May 28, 2003  
NL-03-093

SUBJECT: Indian Point Nuclear Generating Unit No.3  
Docket No. 50-286  
**Proposed Changes to Technical Specifications:  
Pressure-Temperature and Overpressure Protection  
System Limits for Up To 20 Effective Full Power Years**

This amendment request seeks to revise several pages of Section 3.4, including figures, of the Indian Point 3 Technical Specifications. Specifically, the Pressure-Temperature (P/T) and Overpressure Protection System (OPS) limits are being revised from 16.17 Effective Full Power Years (EFPYs) to 20 EFPYs. The previous limit of 16.2 EFPYs was approved by the NRC in Amendment 202 (Reference 1) and was adjusted to 16.17 EFPYs, in Amendment 213 (Reference 2) to support the Appendix K uprate effort. The expiration date reduction was due to higher power rating, not due to a change in vessel embrittlement methodology. An explicit list of changes is contained in Section 2.0 below.

Figure 3.4.3-1:  
Heatup Limitations for the Reactor Coolant System

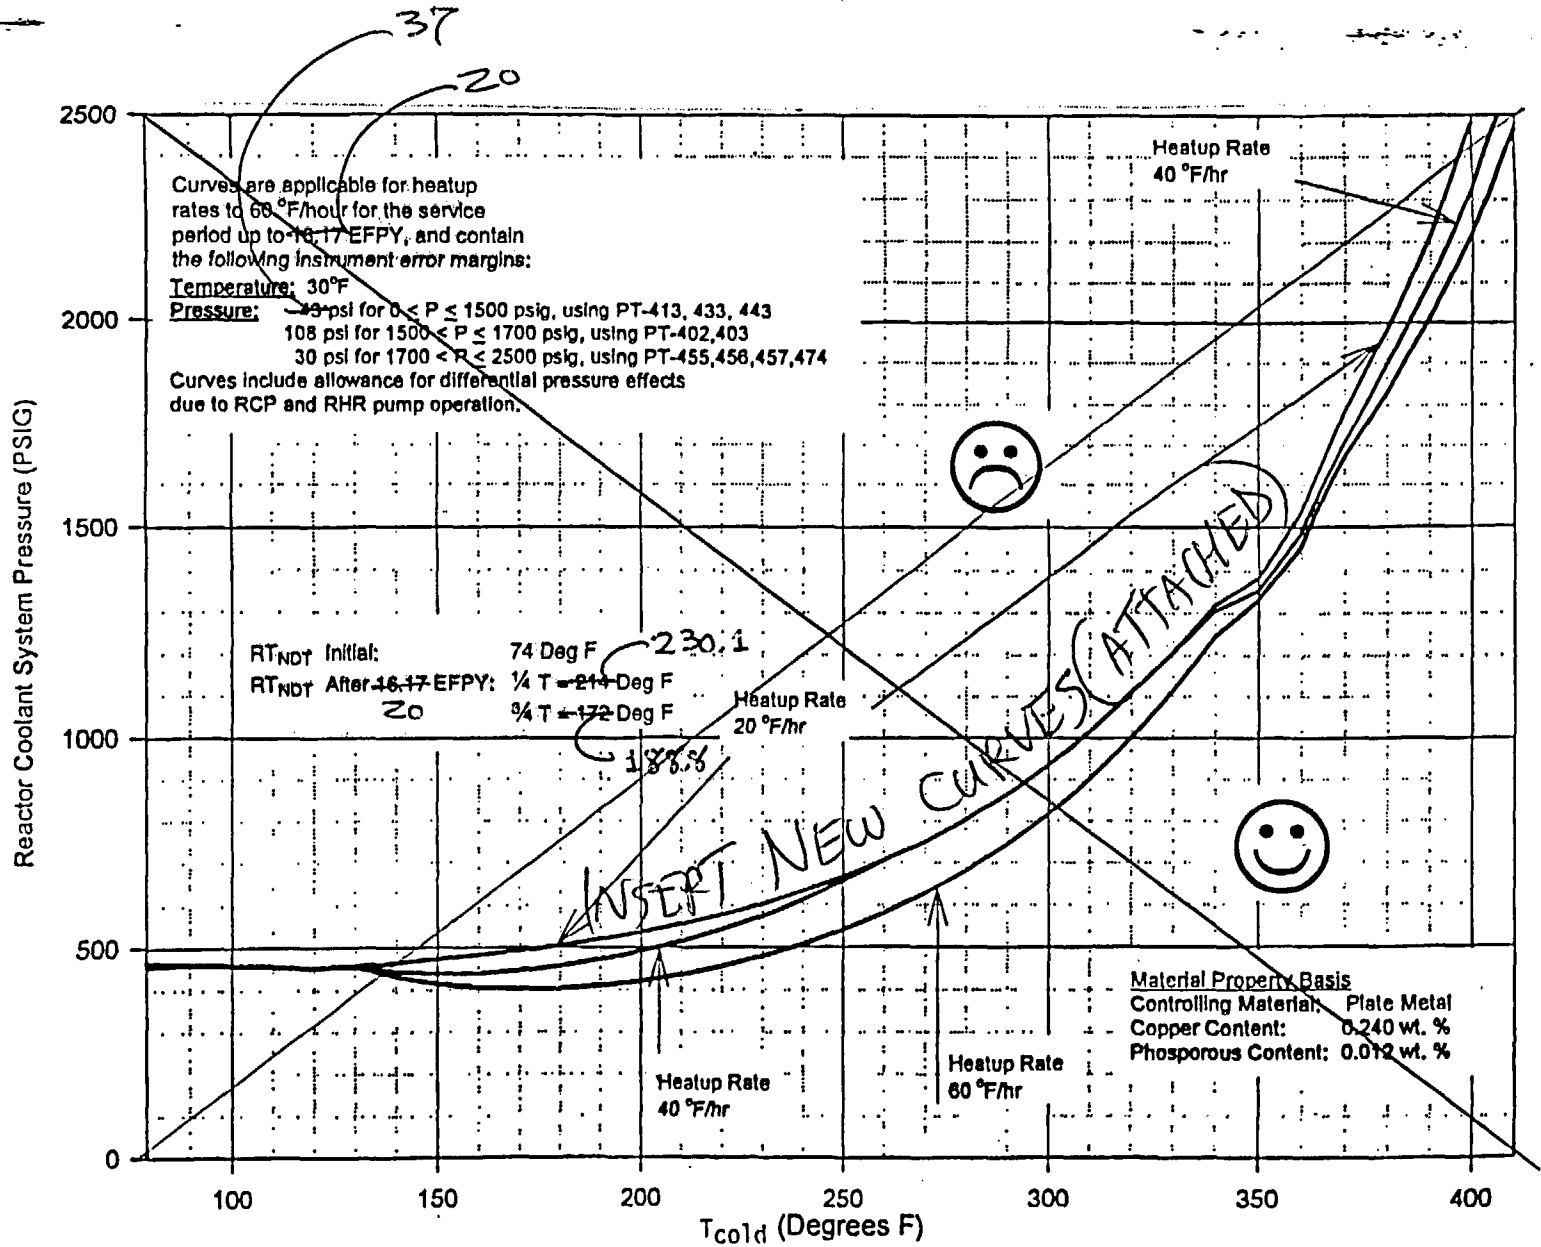
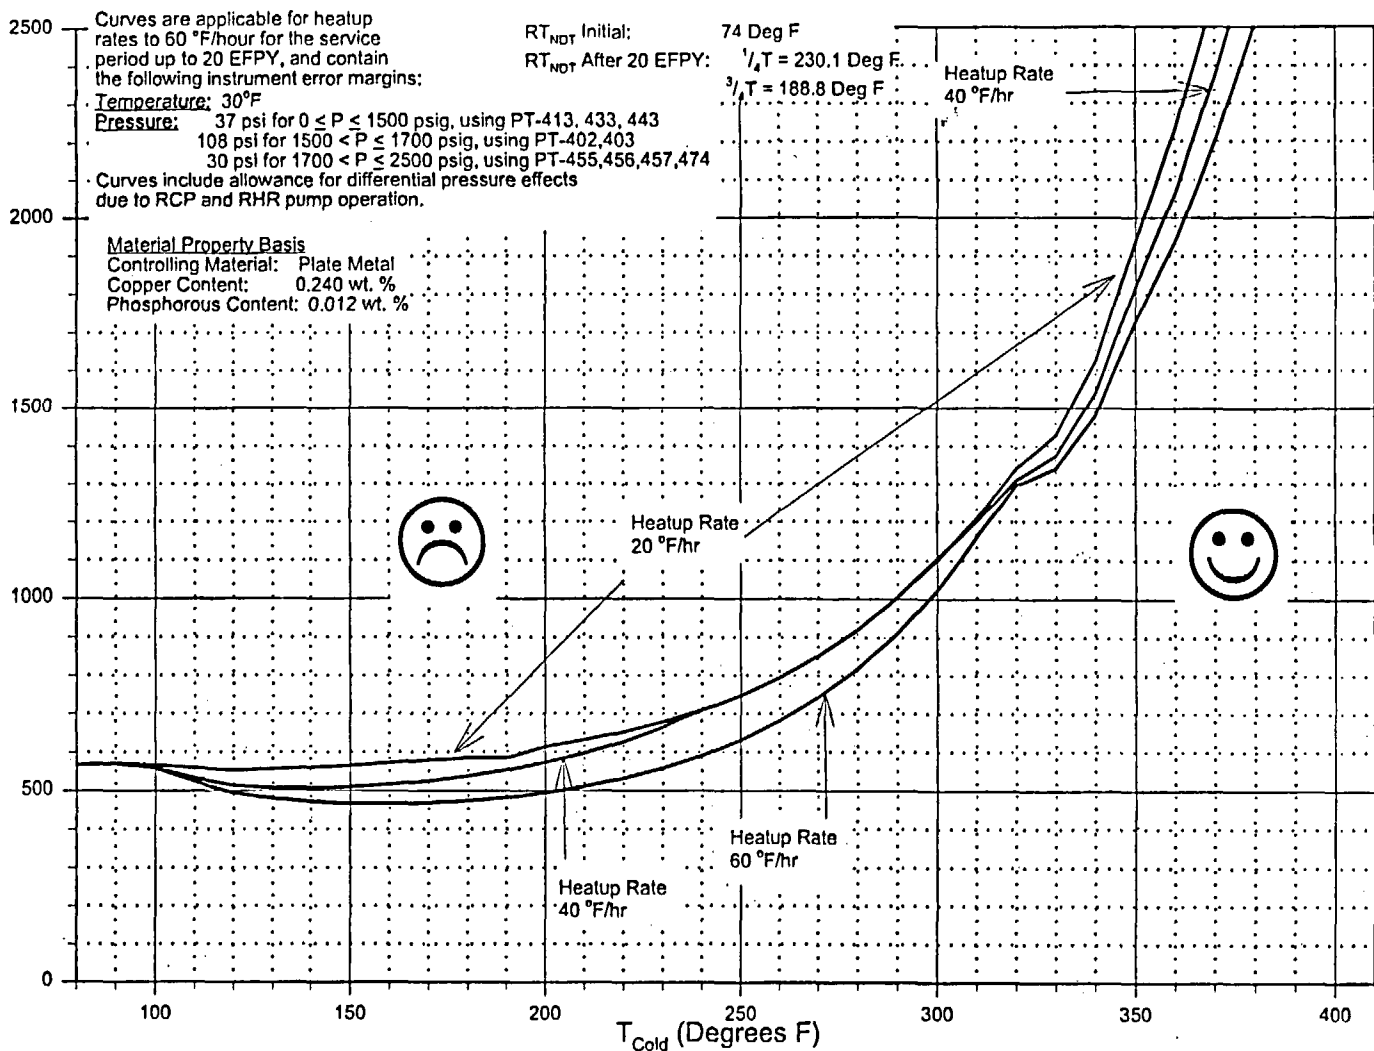
The proposed amendment will revise the curves (included in Attachment II), and the above statement contained on all three figures to read:

**Figure 3.4.3-3:**  
**Hydrostatic and Inservice Leak Testing Limitations for the Reactor Coolant System**

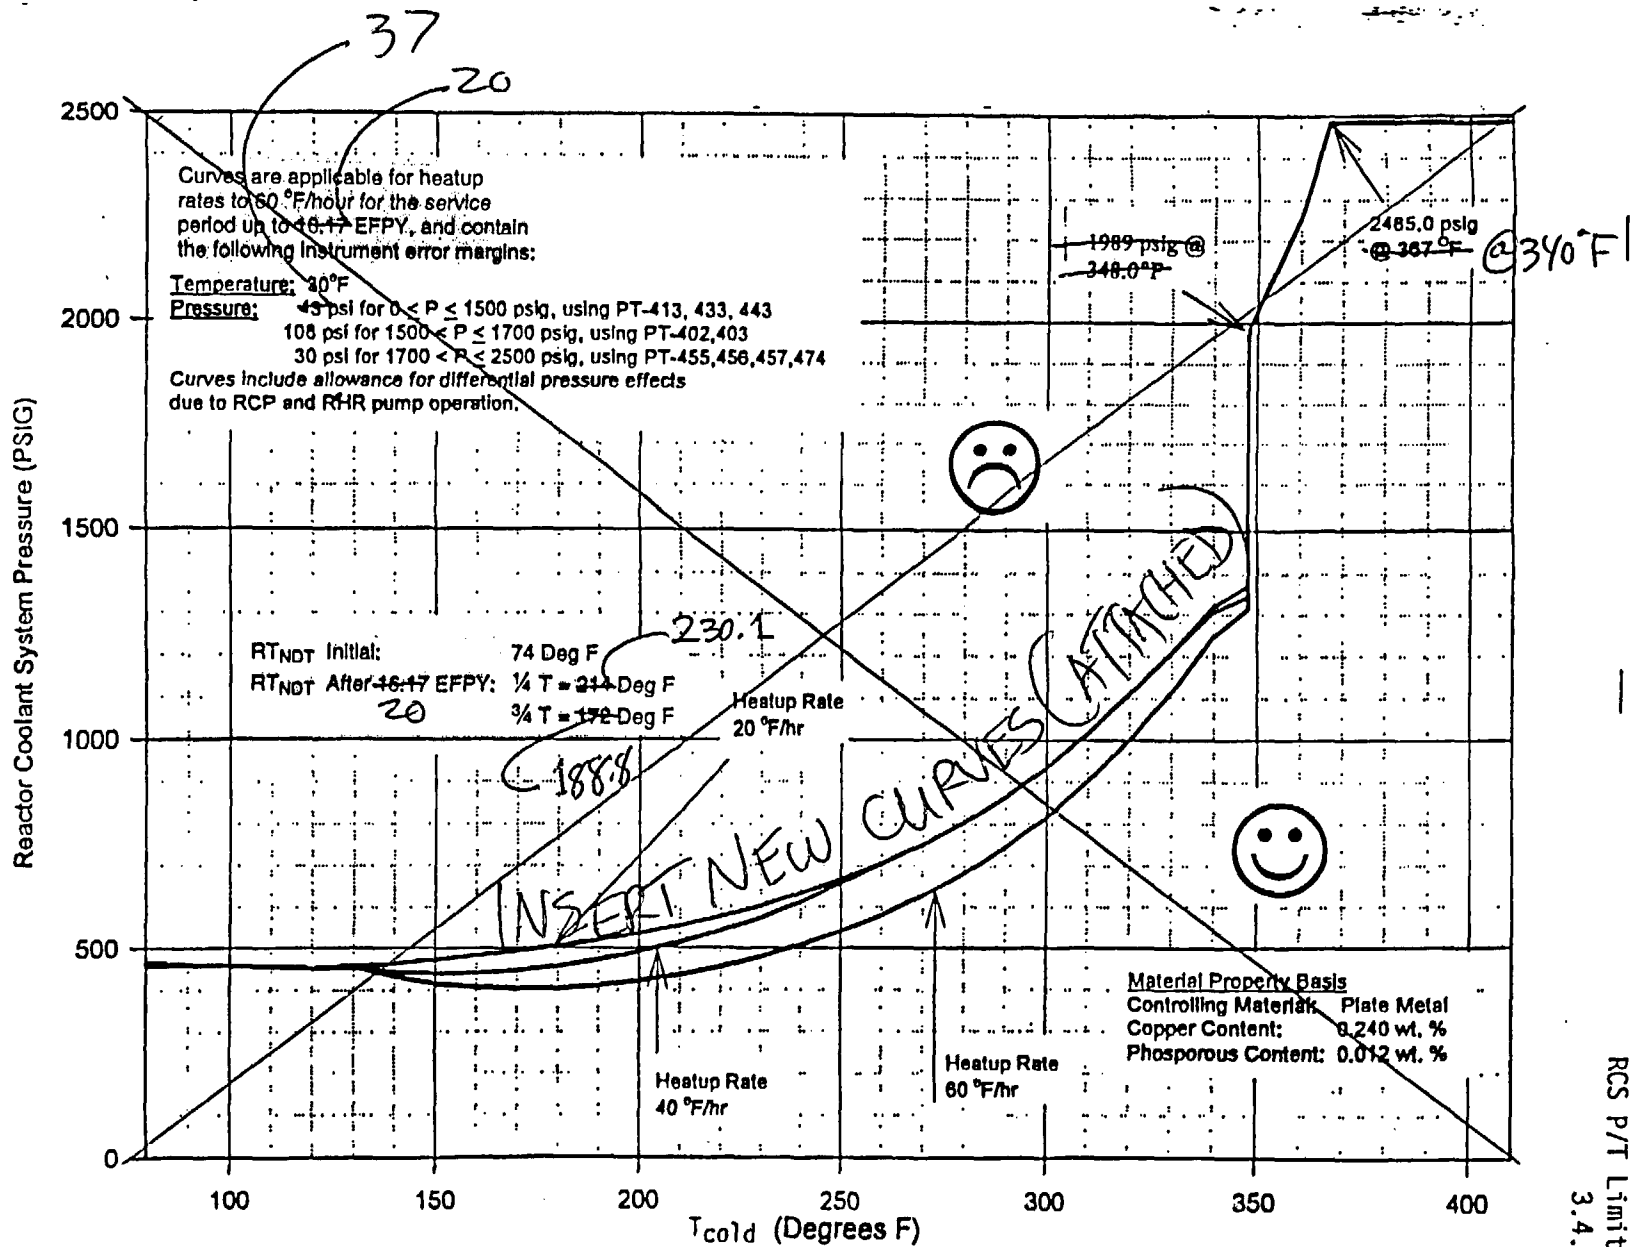
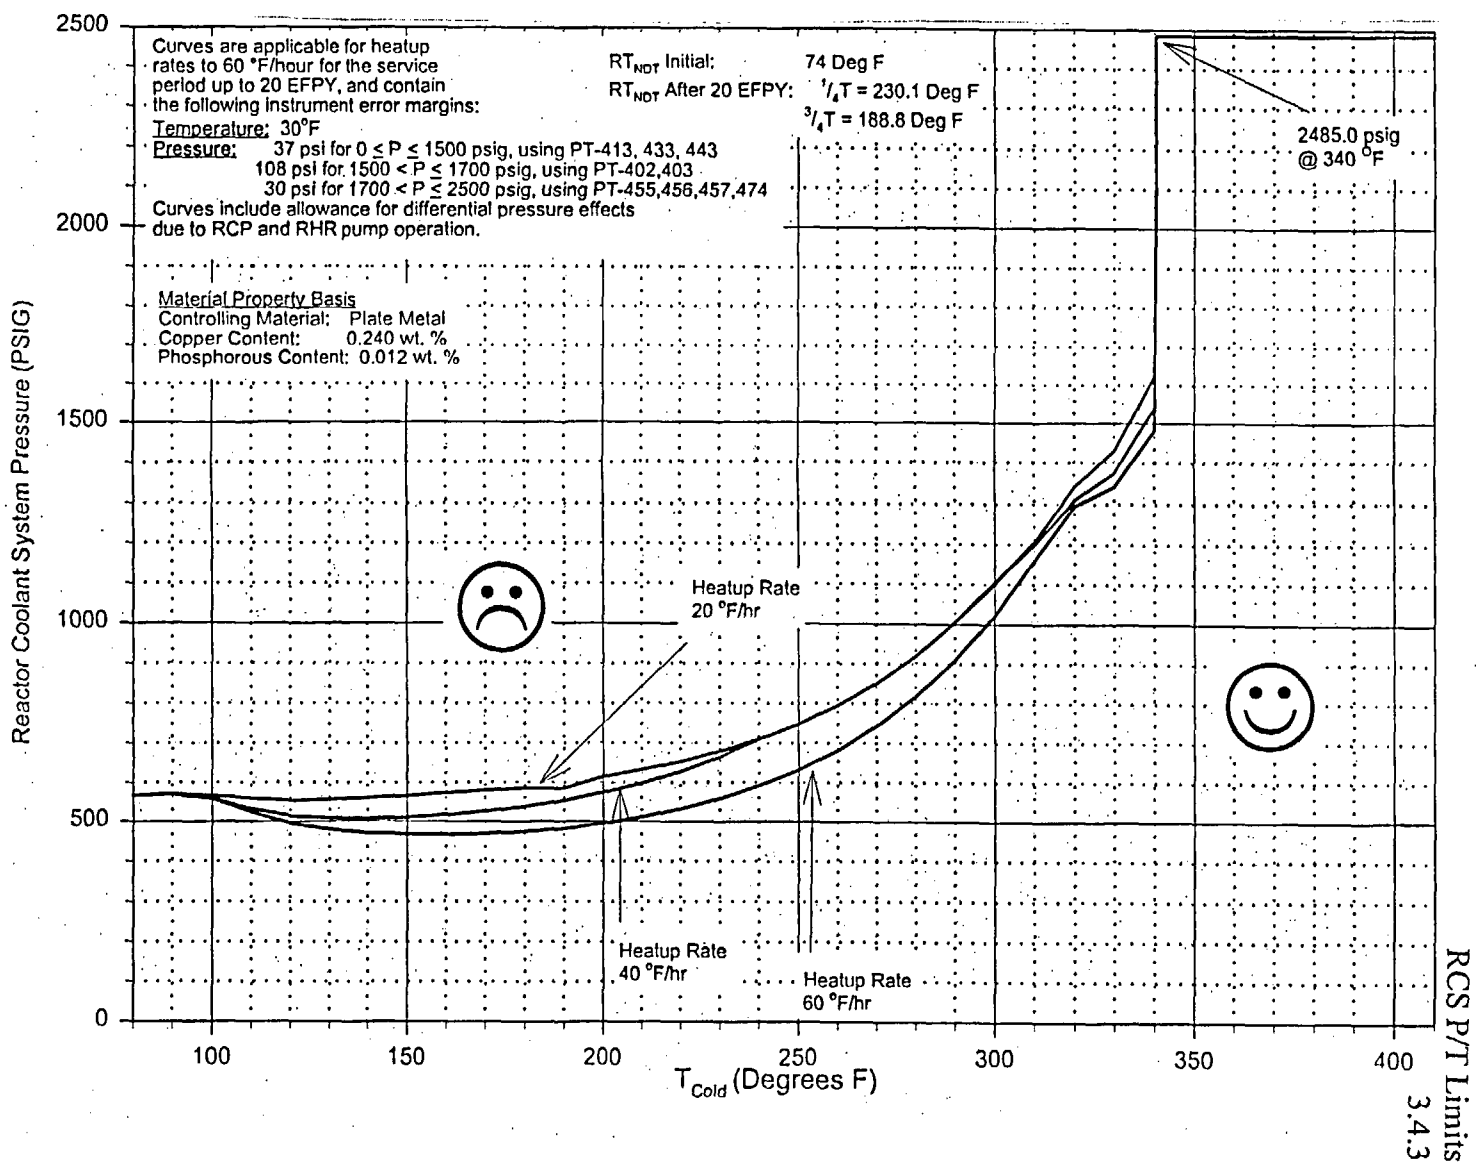
- D. The reference to "1989 psig @ 348.0°F" is being eliminated from Figure 3.4.3-3. Also, "@ 367°F" will be changed to "@ 340°F" on Figure 3.4.3-3.
- E. Indian Point 3 Technical Specification Figure 3.4.12-1 is entitled, in part:

Figure 3.4.12-1: Maximum Allowable Nominal PORV Setpoint for LTOP (OPS). ~~16-17~~ EFPY

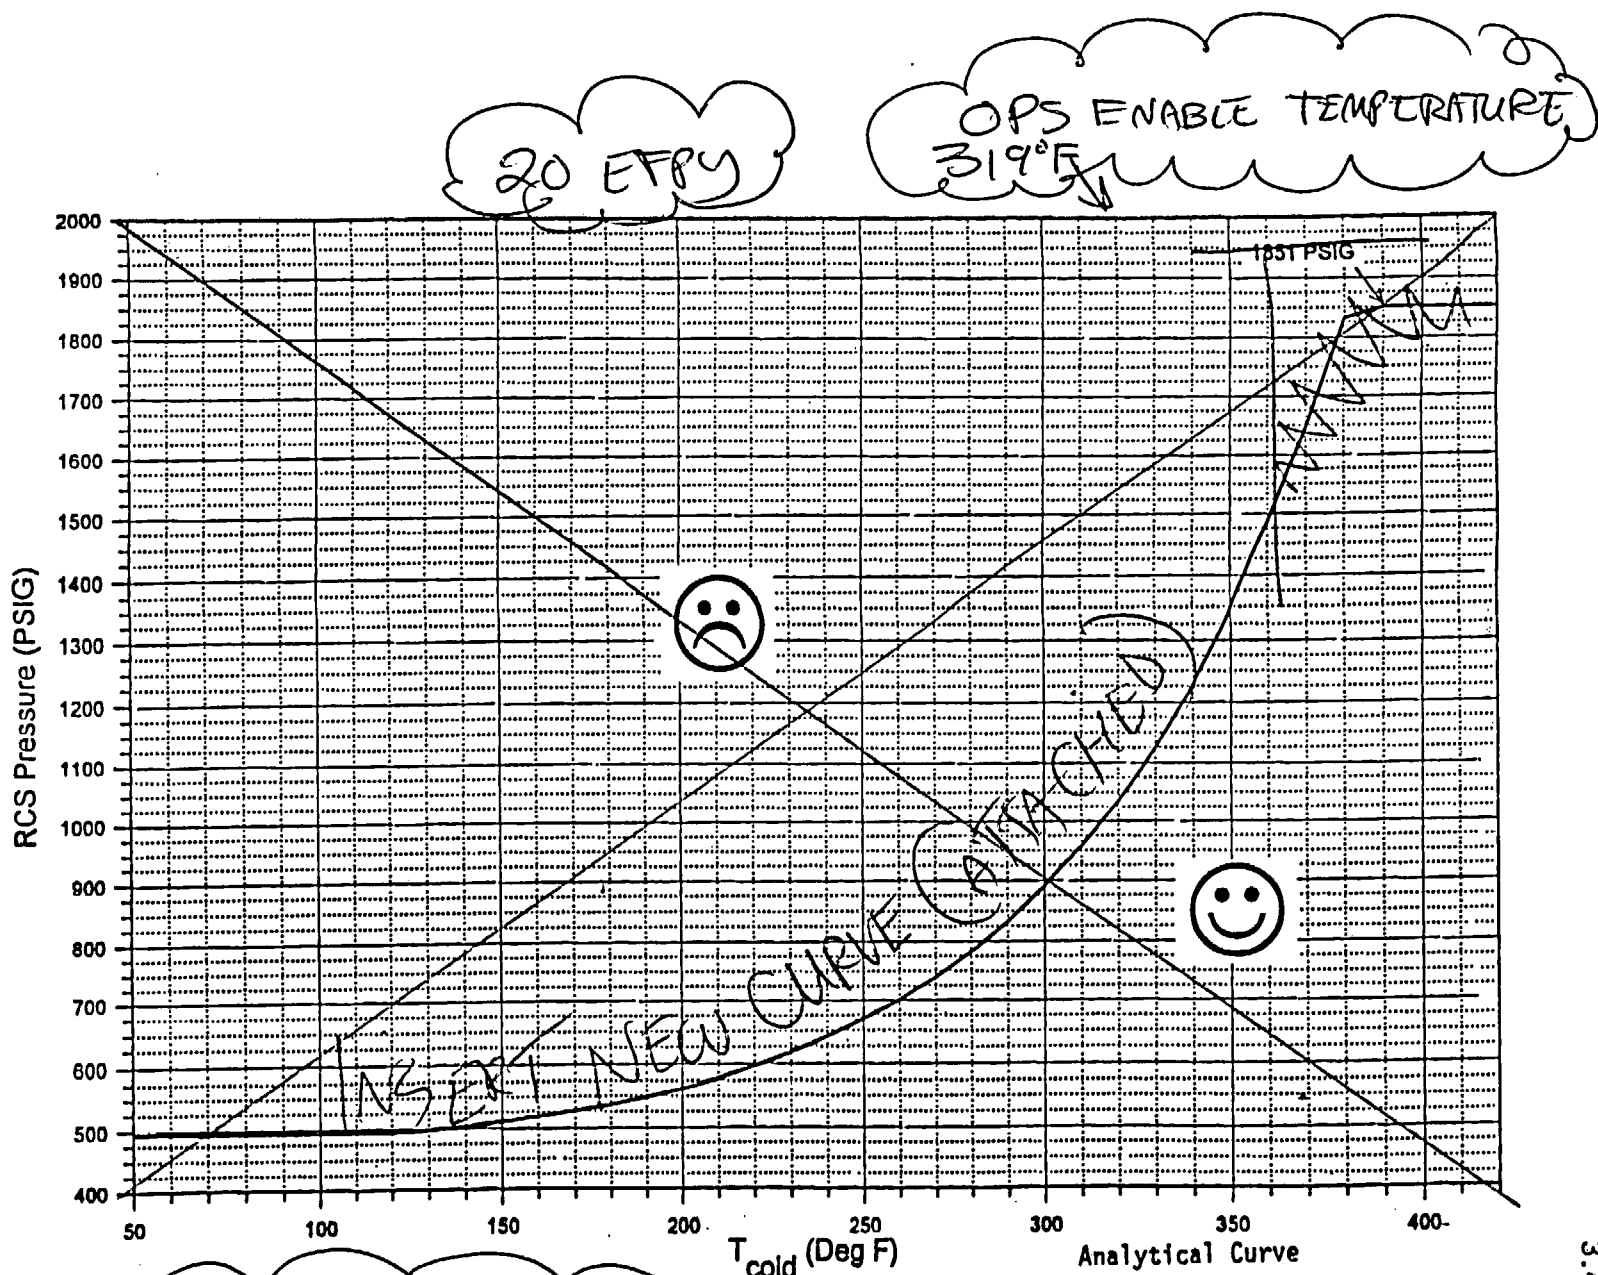
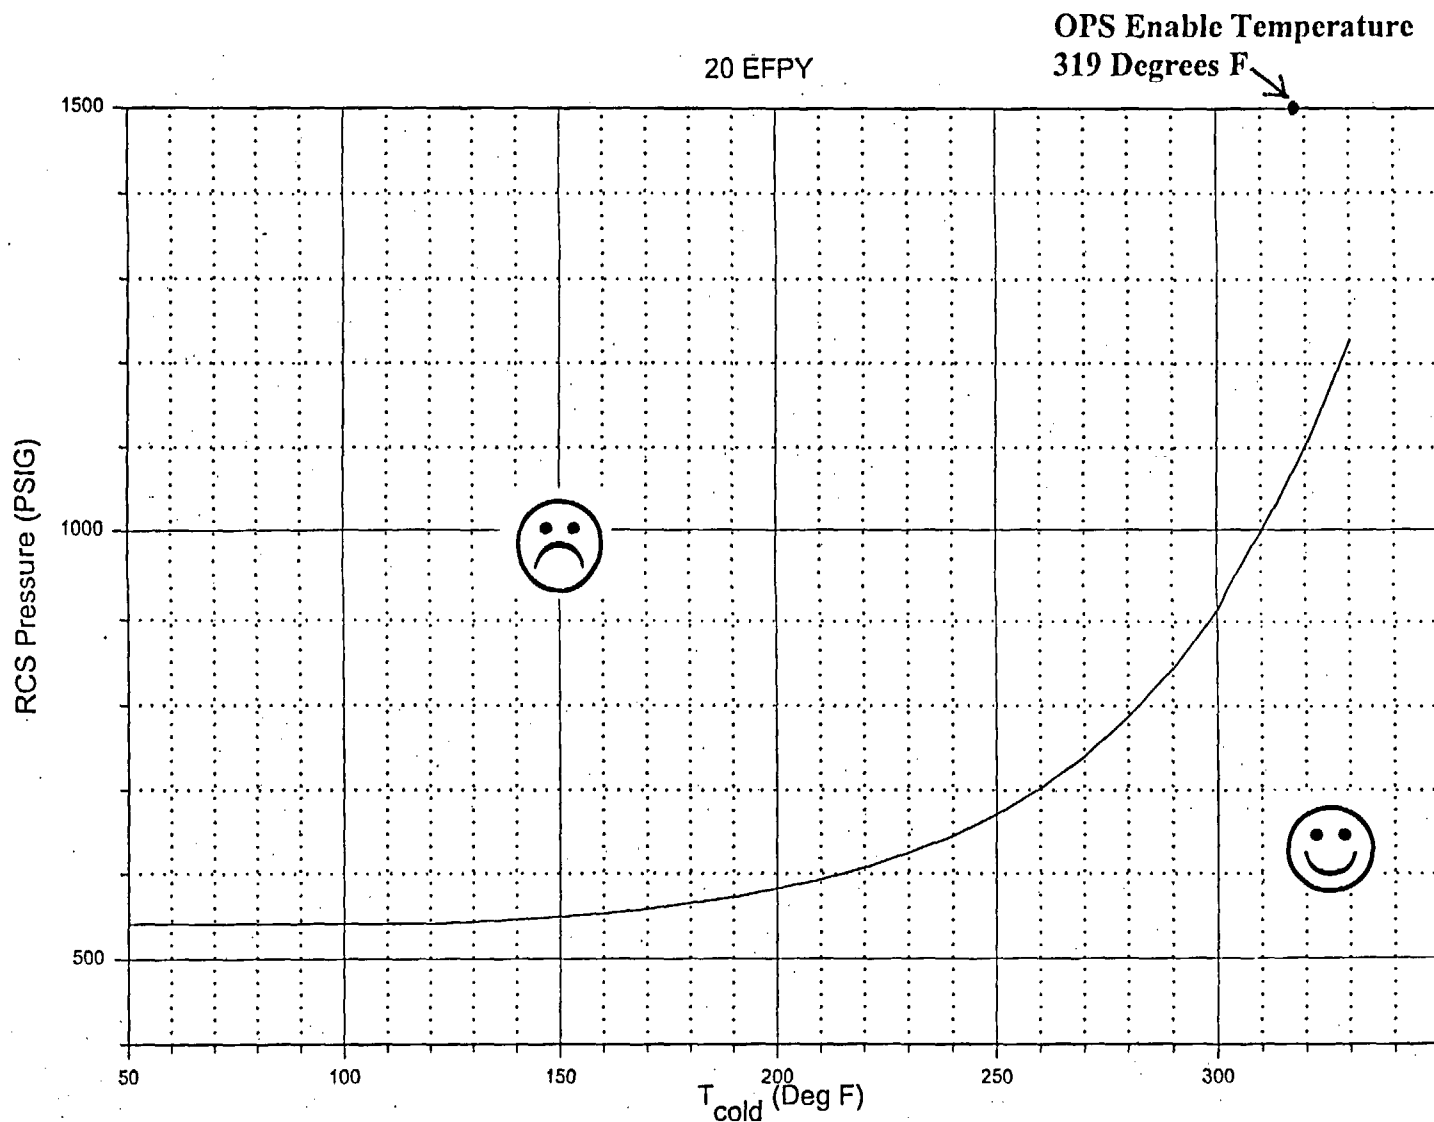
The proposed amendment will revise the curve (included in Attachment II), and, the above statement to read:

"20 EFPY", "OPS Enable Temperature 319°F" and " Note: OPS Enable Temperature includes an allowance of 14.4°F for instrument uncertainty and margin." are, also, being added to Figure 3.4.12-1.

It should be noted that the range of the OPS Setpoint Curve (TS Figure 3.4.12-1) is narrower than in the current TS figure. This is because the original OPS curve covered operation beyond the OPS operating range, up to the point at which the Appendix G limits were protected by the safety valves (411 degF in the current TS, 380 degF in the proposed amendment).

The current TS limit for OPS setpoint pressure levels off at a maximum "ceiling" of 1851 psig. Based on the current analysis (Reference 2), the ceiling for OPS pressure at an OPS Enable Temperature of 319 degF is 2030 psig. This pressure does not appear on Figure 3.4.12-1, as it is higher than any pressure along the entire range of the curve.

Figure 3.4.12-1: Maximum Allowable Nominal PORV Setpoint for  
LTOP (OPS), 20 EFYP

Note: OPS Enable Temperature  
includes an allowance of 14.4 degF  
for instrument uncertainty and margin.
